TOWN OF PLAINFIELD DESIGN REVIEW COMMITTEE

DATE: 12-09-2025
CASE NO.: DP-25-097
Project Page: [Zaxby's Main at Smith](#)
PETITIONER: Jessica Hood, Carter Engineering on behalf of Zaxby's
REQUESTED ACTIONS: Architectural and Site Design Review for a proposed drive-thru restaurant of approximately 2,300 square feet in size.
LOCATION: 2560 East Main Street
PARCEL SIZE: .965 acres +/-

Similar to Proposed Plainfield Location (Located in Columbus, IN)

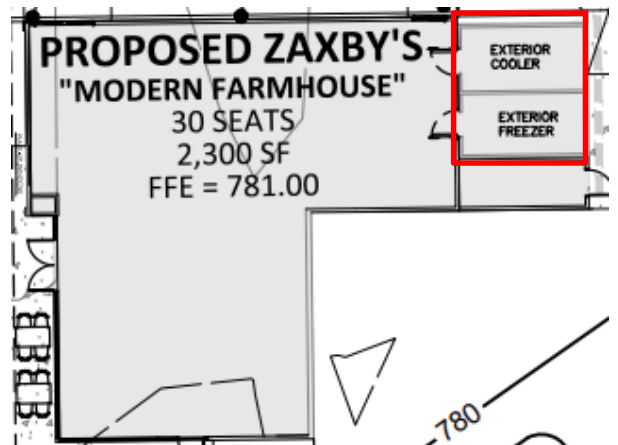
Zaxby's website claims that the company's new Modern Farmhouse restaurant format being proposed is "designed to maximize operational efficiency and profitability".

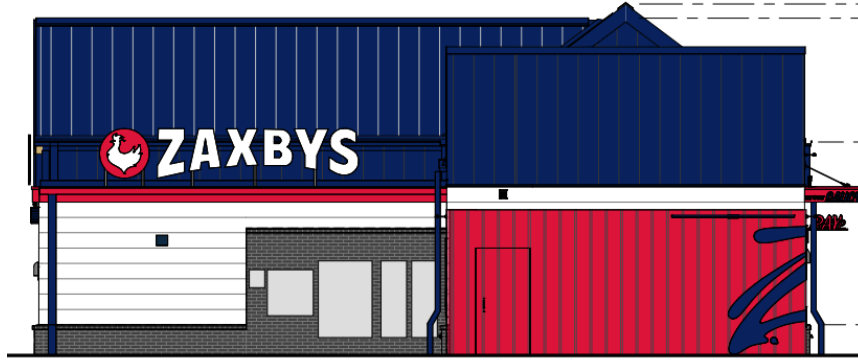
The applicant mistakenly gave themselves façade material points for “metal accents” which are not rewarded points under the Plainfield Zoning Ordinance. The East elevation, which is oriented most directly at U.S. 40 and Smith Road, does not meet Town standards for material usage based on Staff’s calculations. The elevation shown on the left is what is proposed to be fronting the corner of Smith Road & Main Street. The red part of the elevation is the cooler/freezer screening.

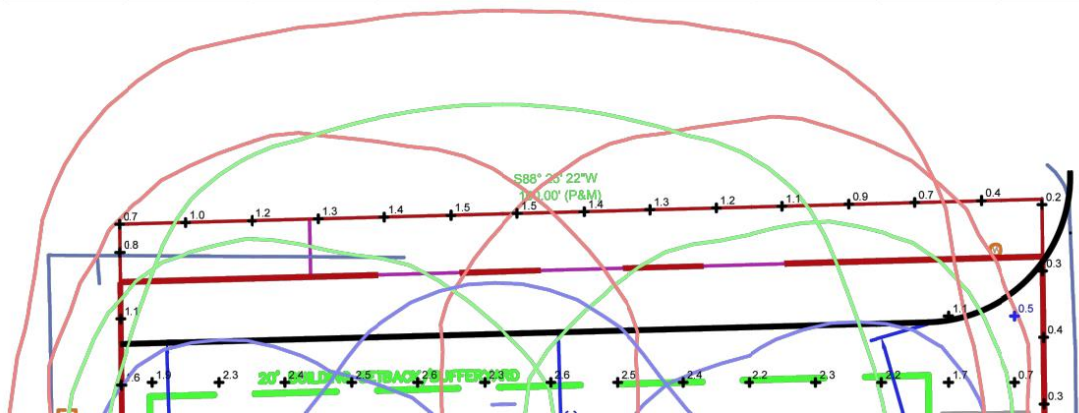
7. Lighting shall not cause illumination beyond any lot line, except for common lot lines in commercial or industrial areas which utilize the development incentive for the use of required yards in integrated centers or industrial parks;

The applicant's lighting plan indicates that illumination beyond lot lines is occurring. This is especially concerning on the north end of the property, which abuts residential zoning. The footcandle map as well as the provided lighting statistics have been included below.
